RE: DUANE ARNOLD ENERGY CENTER (DAEC)

Amendment No. 37
License No. DPR-49

ATTACHMENT TO LICENSE AMENDMENT NO. 37

SUPPORTING AMENDMENT NO. 37 TO LICENSE NO. DPR-49

DUANE ARNOLD ENERGY CENTER IOWA ELECTRIC LIGHT & POWER COMPANY TECHNICAL SPECIFICATIONS
LIMITING AVERAGE PLANAR LINEAR HEAT GENERATION RATE AS A FUNC- OF PLANAR AVERAGE EXPOSURE FUEL TYPE: INTIAL CORE TYPE 1 & 3 FIGURE 3.12-2

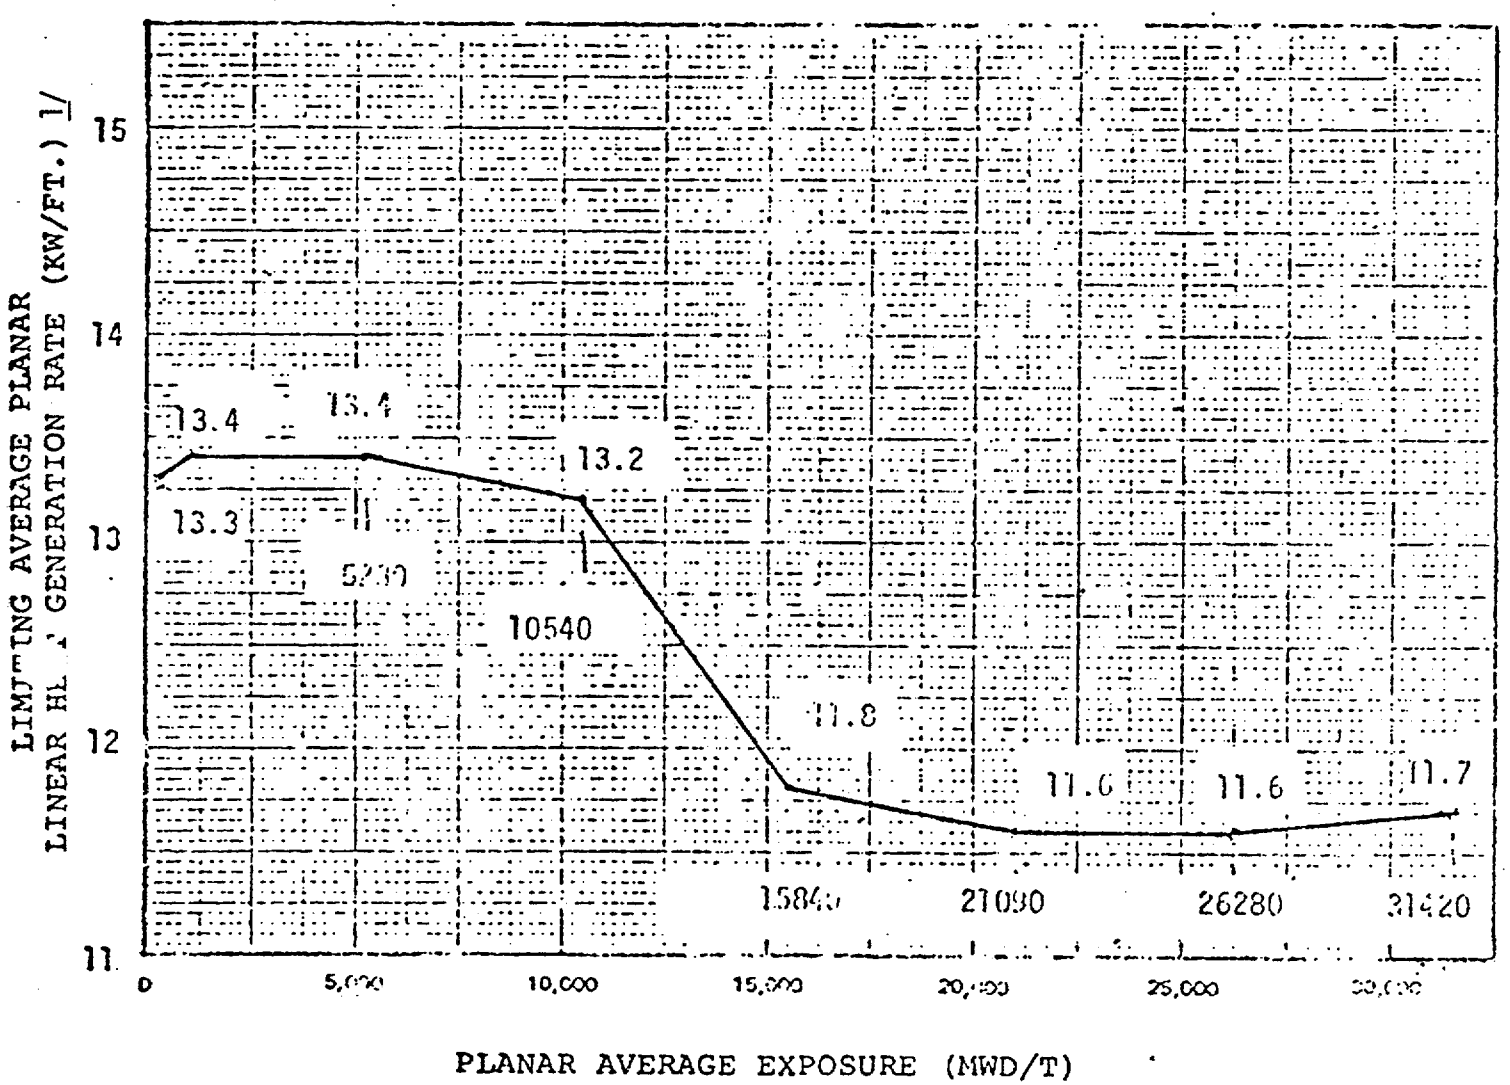
1/ When core flow is equal to or less than 70% of rated, the MAPLHGR shall not exceed 95% of the limiting values shown.

FIGURE 3.12-3

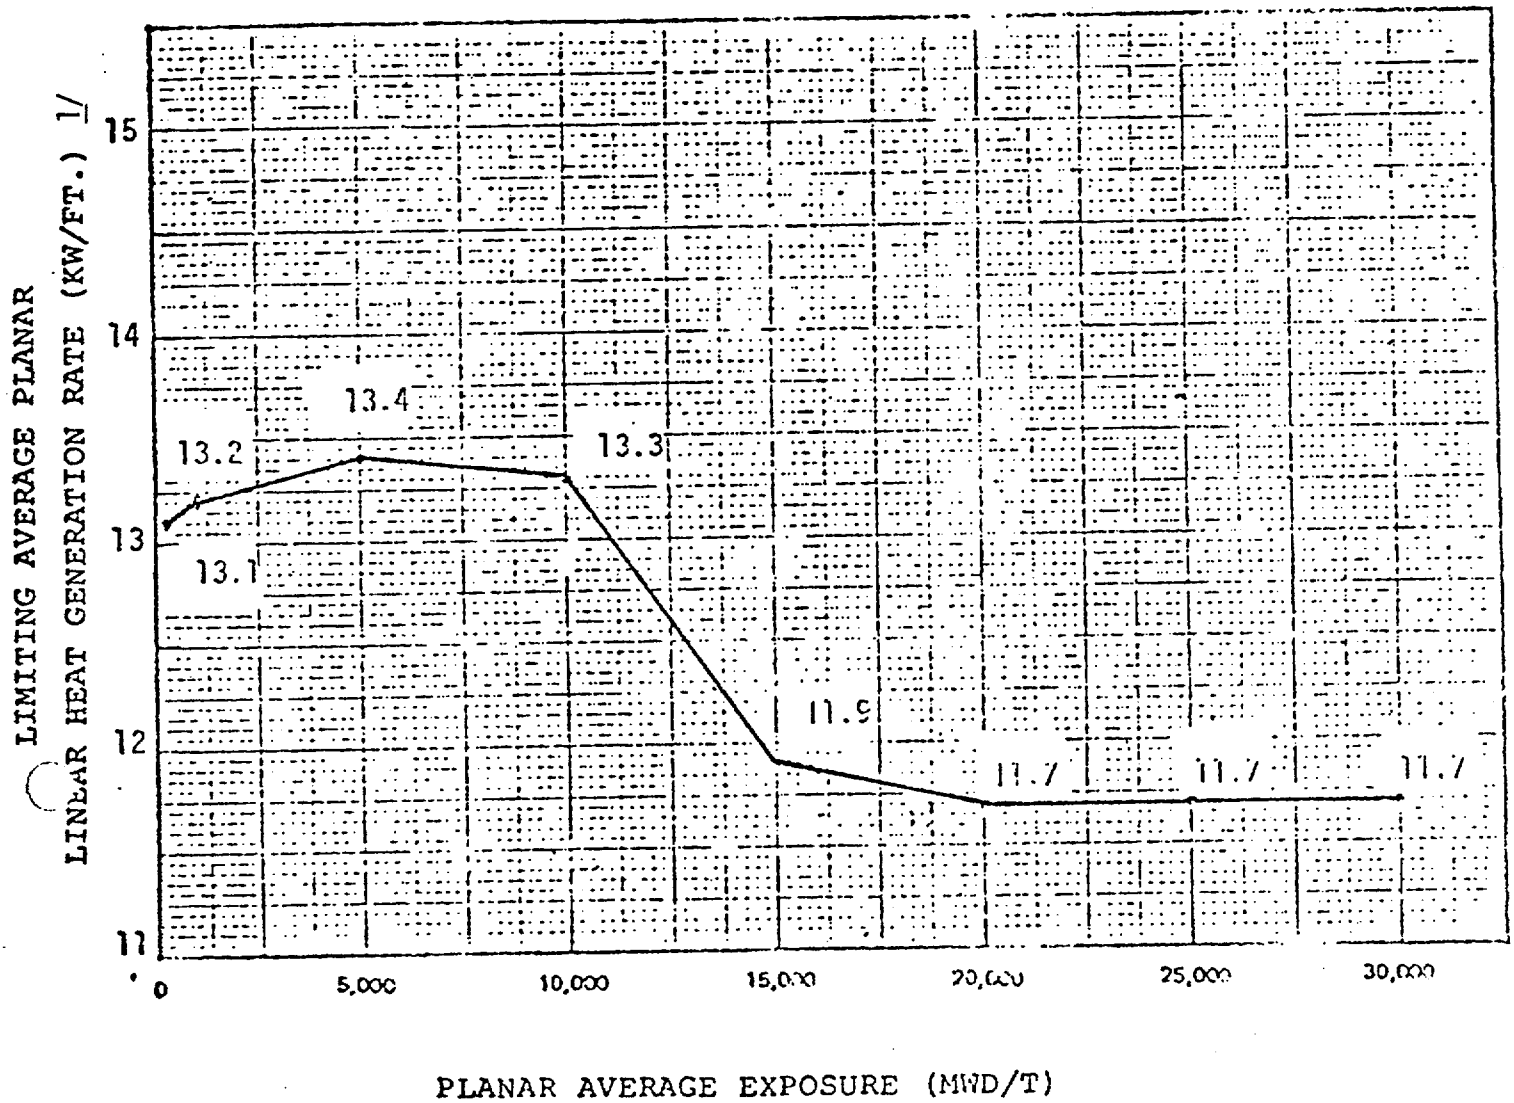
1/ When core flow is equal to or less than 70% of rated, the MAPLHGR shall not exceed 95% of the limiting values shown.

FIGURE 3.12-4

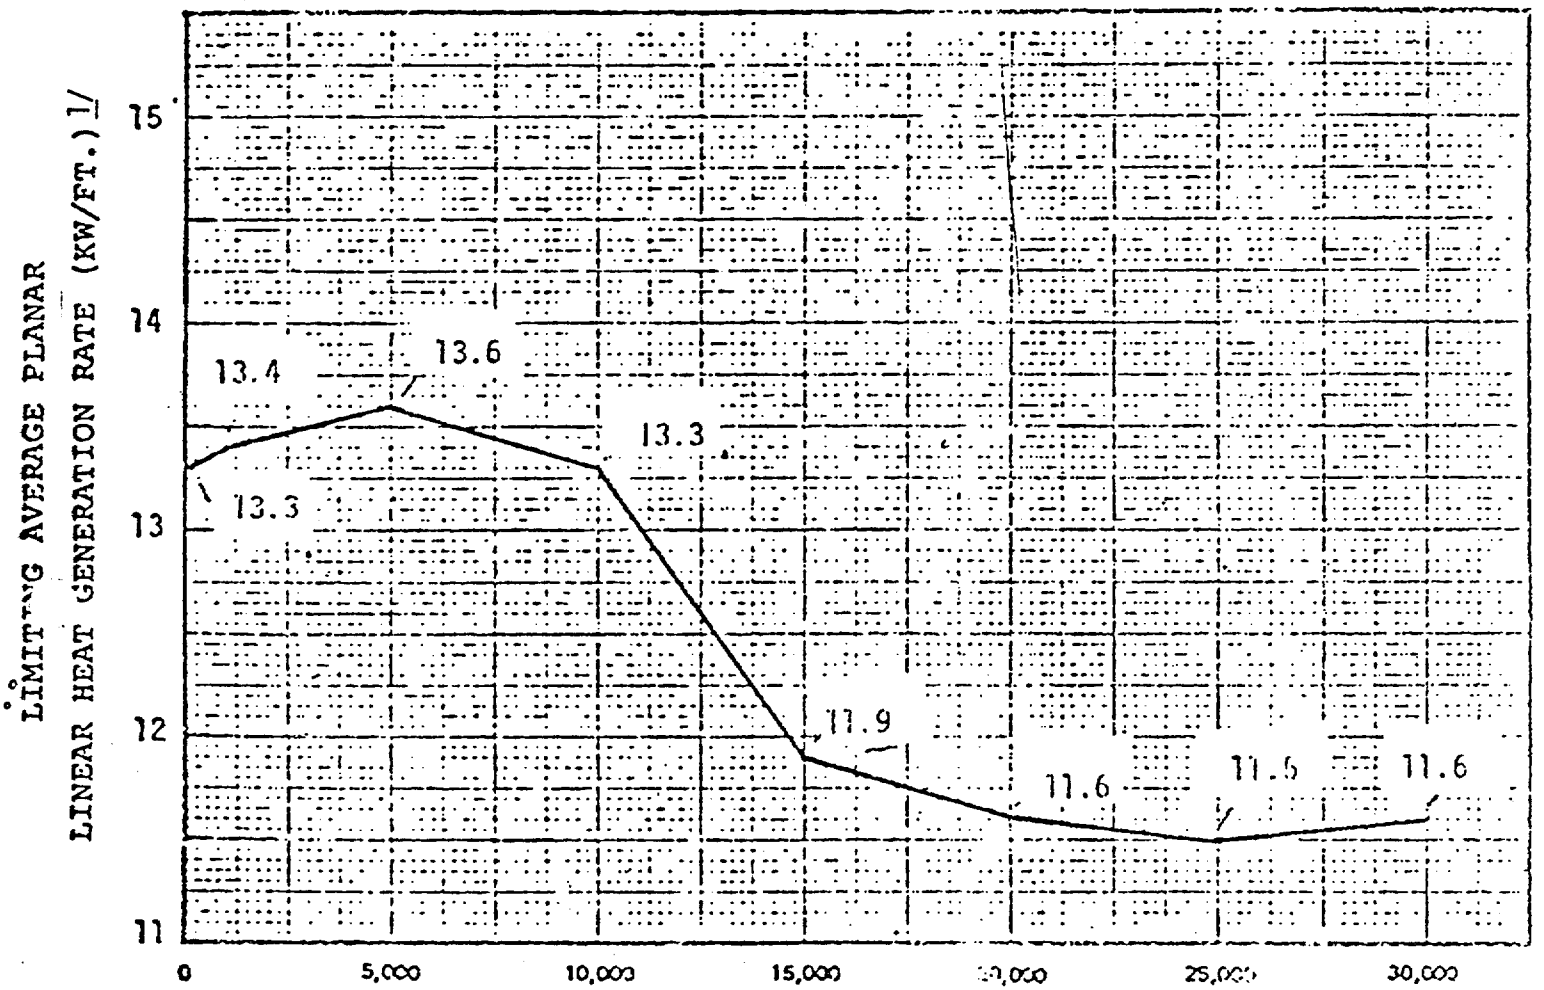
1/ When core flow is equal to or less than 70% of rated, the MAPLHGR shall not exceed 95% of the limiting values shown.

DUANE ARNOLD ENERGY CENTER IOWA ELECTRIC LIGHT AND POWER COMPANY TECHNICAL SPECIFICATIONS
LIMITING AVERAGE PLANAR LINEAR HEAT GENERATION RATE AS A FUNCTION OF PLANAR AVERAGE EXPOSURE FUEL TYPE: 8D274 FIGURE 3.12-5

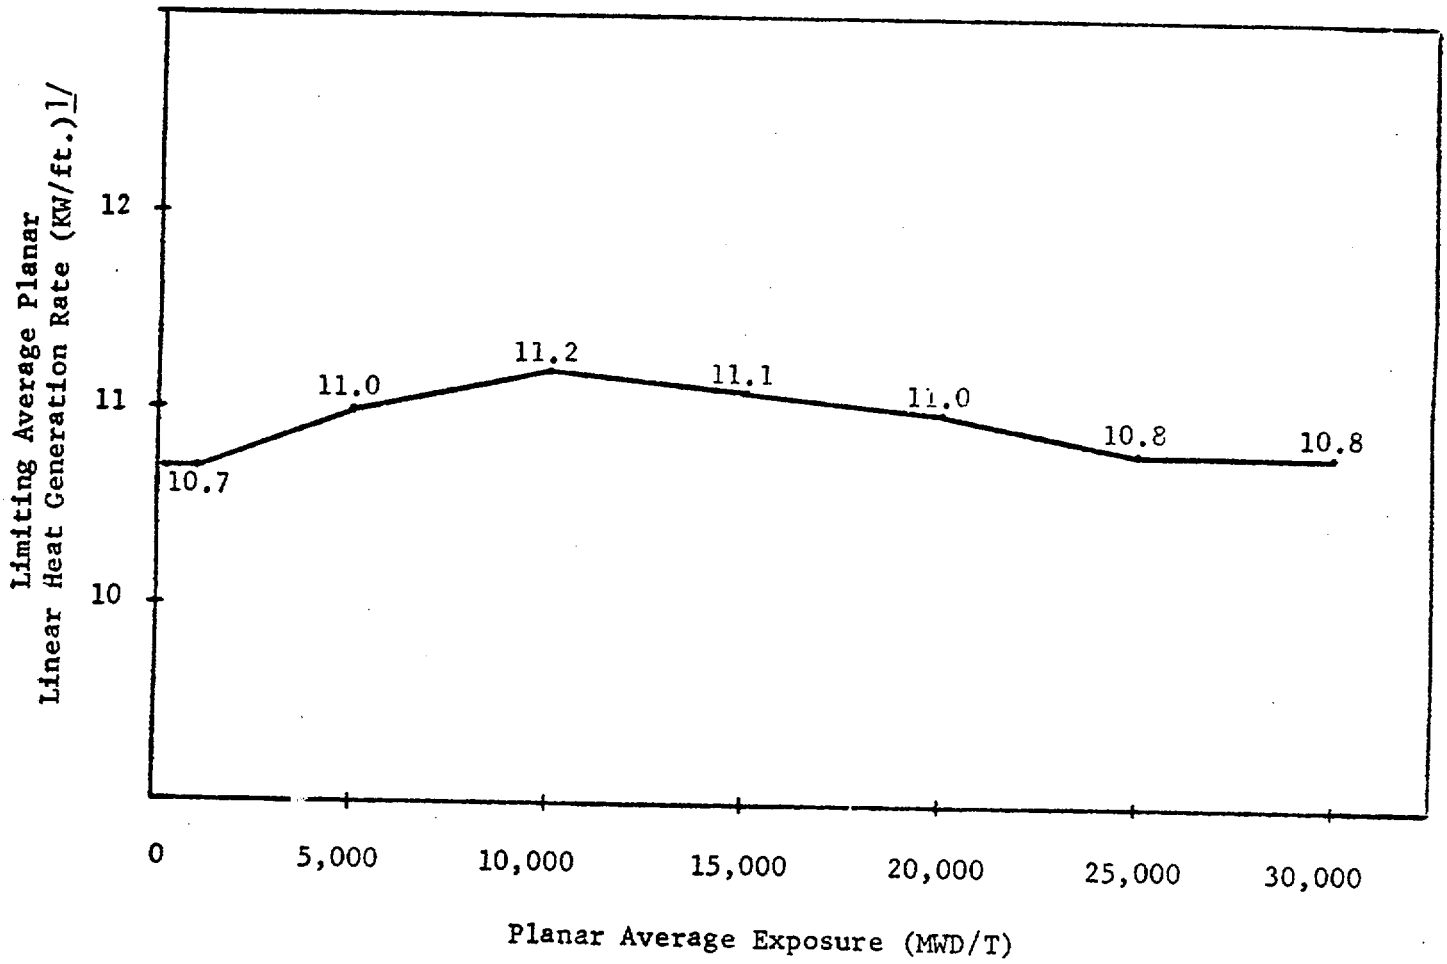
1/ When core flow is equal to or less than 70% of rated, the MAPLHGR shall not exceed 95% of the limiting values shown.
